UNITED STATES PATENT AND TRADEMARK OFFICE

Office Action Summary	Application No. 10/526,998	Applicant(s) FERNANDEZ, FRANCESC XAVIER HERNANDO	
	Examiner Vinod D. Patel	Art Unit 3742

DETAILED ACTION

FIG. 20

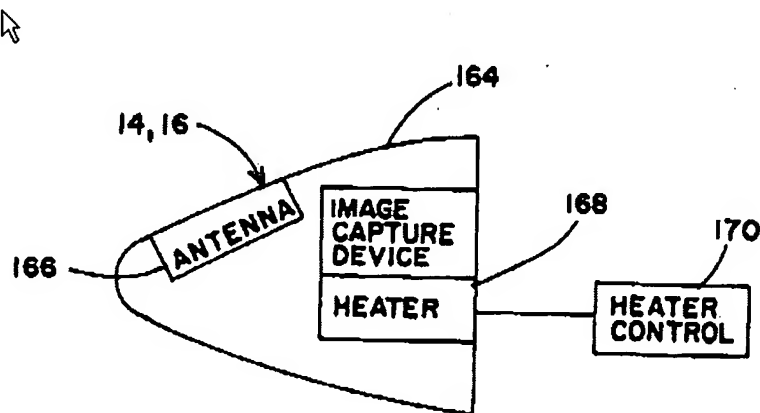
With respect to claim 28, Schofield et al. discloses an image acquisition unit (14, 16) with a heating device (168) for monitoring an exterior of a vehicle, comprising: a casing comprising a protected interior, a window closed by a transparent element and supporting means for supporting an optical system facing said window; image detection means located in said casing, facing said optical system and associated with connection means with the exterior, for supplying electrical signal and/or for bidirectional signal interchange; and heating means for providing thermal energy to said transparent element, or to an adjacent zone thereto as shown in the Figure 20.

With respect to claim 29, Schofield et al. discloses the image acquisition unit, wherein said heating means comprises at least one electrical heater (168) supplied with direct current from said connection means (Figure 20, column 20, lines 13-40).

With respect to claim 30, Schofield et al. discloses the image acquisition unit, further comprising control means (170) for controlling the operation of said electrical heater as shown in the Figure 20.

With respect to claim 37, Schofield et al. discloses the image acquisition unit, wherein said electrical heater comprises at least one electrical resistance directly applied on said transparent element as shown in the Figure 20.

FIG. 1

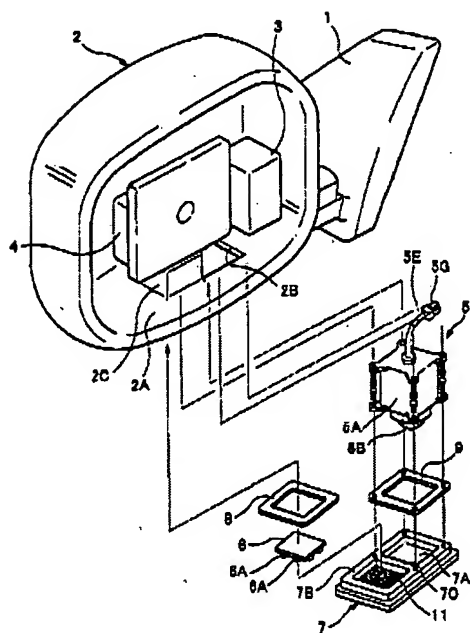
17. Applicant's arguments filed 10/5/07 have been fully considered but they are not persuasive. Fujikawa discloses a casing (2) comprising a protected interior, said casing defining a window closed by a transparent element (7) and supporting means defined by part of said casing for supporting an optical system inside said casing for supporting an optical system inside said casing and facing said window, image detection means located in said casing, facing said optical system and associated with connection means with the exterior for supplying electrical signals and for bidirectional signal interchange as shown in the Figures 1-7.

Sheet 11 of 13

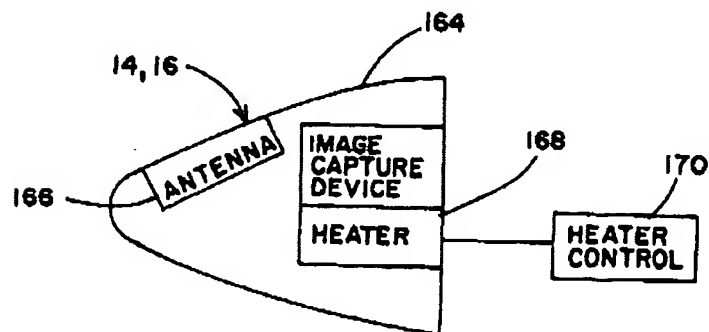
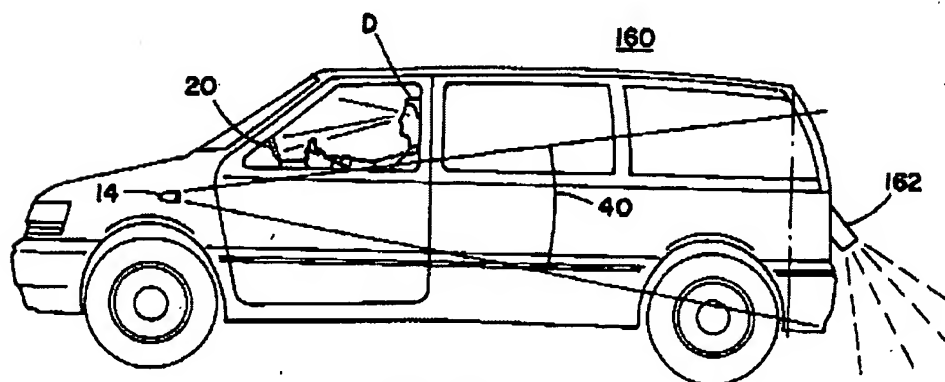
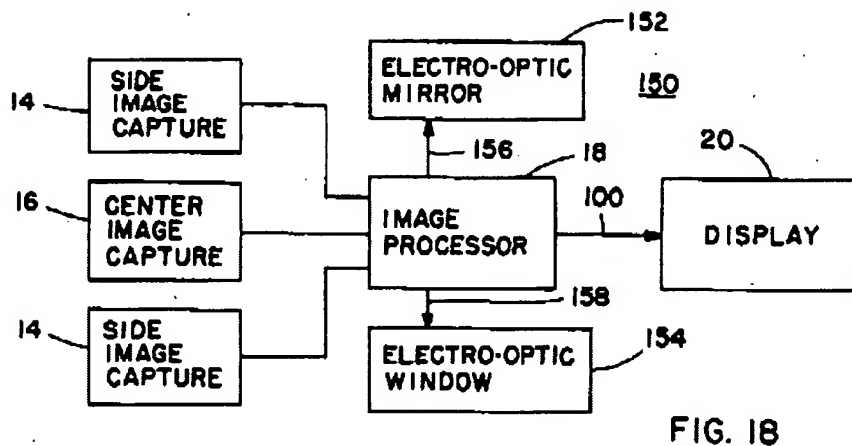
In response to the applicant argument that Schofield does not disclose heater 168 provides thermal energy to transparent element. The examiner respectfully disagrees with that statement. Heater 168 provides thermal energy to transparent element, see, Schofield discloses, column 18, lines 41-42, "A heater may be applied to each image capture device in order to remove dew and frost that may collect on the optics of the device.", column 20, lines 22-40 and column and column 20, lines 22-36, "A heater 168 may be associated with the image capture device in order to stabilize the temperature of the device in low ambient temperature conditions. A similar heater may be supplied in display 20 in order to improve its performance in low ambient temperature conditions. A heater control 170 is provided in order to control the energization of heater 168 and, if utilized, the heater in the display. Heater control 170, preferably, energizes heater 168 prior to the vehicle being started. This allows the temperature of the image capture device to be elevated to a more desirable temperature prior to the driver operating the vehicle. This may be accomplished by heater control 170 being a proximity detector which detects a device carried by the driver as the driver approaches the vehicle."

With respect to claim 37, Schofield discloses, column 18, lines 41-42, "A heater may be applied to each image capture device in order to remove dew and frost that may collect on the optics of the device.", column 20, lines 22-40 and column and column 20, lines 22-36, "A heater 168 may be associated with the image capture device in order to stabilize the temperature of the device in low ambient temperature conditions. A similar heater may be supplied in display 20 in order to improve its performance in low ambient temperature conditions. A heater control 170 is provided in order to control the energization of heater 168 and, if utilized, the heater in the display. Heater control 170, preferably, energizes heater 168 prior to the vehicle being started. This allows the temperature of the image capture device to be elevated to a more desirable temperature prior to the driver operating the vehicle. This may be accomplished by heater control 170 being a proximity detector which detects a device carried by the driver as the driver approaches the vehicle." Based on that, an electrical heater is used to remove dew and frost that may collect on the optics device. During examination, claim limitations are to be given their broadest reasonable reading. In re Zletz, 893 F.2d 319, 321, 13 USPQ2d 1320, 1322 (Fed. Cir. 1989); In re Prater, 415 F.2d 1393, 1404-05, 162 USPQ 541, 550-51 (CCPA 1969).
